Ashburton District Council

26th February 2025

**RE: LUC250001 - RESPONSE TO RFI MATTERS – PROPOSED MIDLANDS PROPERTIES –
ADMINISTRATION/OFFICE AND SEED TRIAL FACILITY – RACECOURSE ROAD, ASHBURTON**

Clause 3:

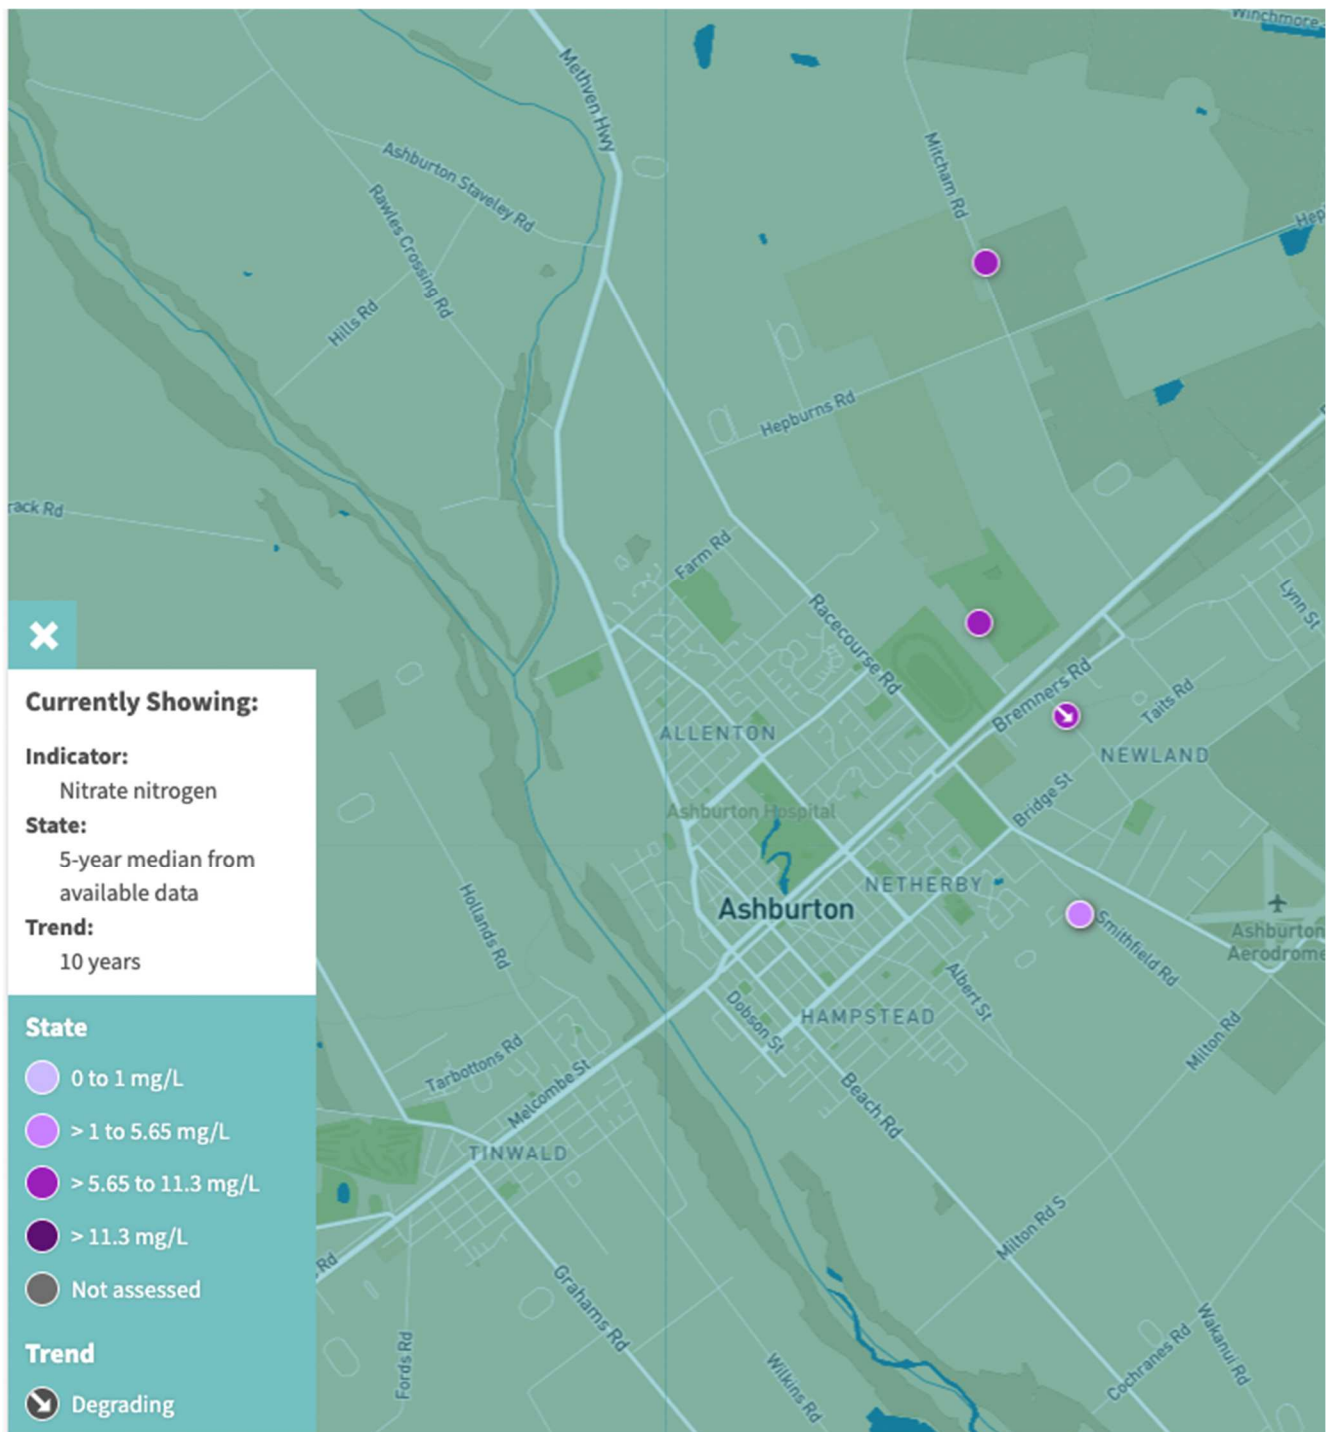
In terms of Clause 3 the following comments are relevant.

- (a) The closest wastewater (reticulated) is over 2km away (Carters/Farm Road intersection)
- (b) There is no soil contamination (HAIL) activity registered to this site.
- (c) n/a
- (d) Will not enter any surface water body. Closest is over 170m away (stockwater race running parallel to SH 77) upgradient of the site.
- (e) Over 20m away from waterbody
- (f) The closest bore is the applicants own bore K37/0836 (an irrigation and domestic supply bore) which is over 250m west from the building and discharge area.
- (g) There is no Community Drinking Water supply protection zone on this site.
- (h) The highest groundwater level at bore K37/0836 was -4.3mbgl. Therefore, there is ample separation between the proposed onsite wastewater discharge and highest HGL. A system would be designed to avoid any potential groundwater contact.
